Ardmore Park Quarry – Modification 3

## Post Construction Phase Road Safety Audit of the Product Delivery Route

Ref. 17126 RSA Existing Road

**TABLE 3.1 TRANSPORT ROUTE - JERRARA ROAD AND MOUNTAIN ASH ROAD FROM HUME HWY TO PRIVATE ENTRANCE (BUNGONIA BYPASS)**

Item 5

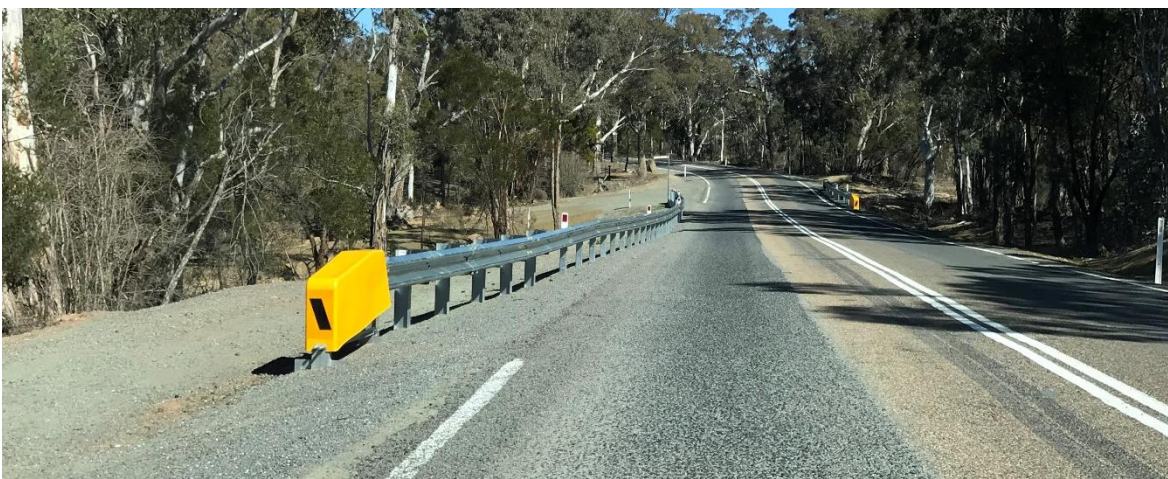
Edgeline missing on southbound carriageway of Water Course Crossing
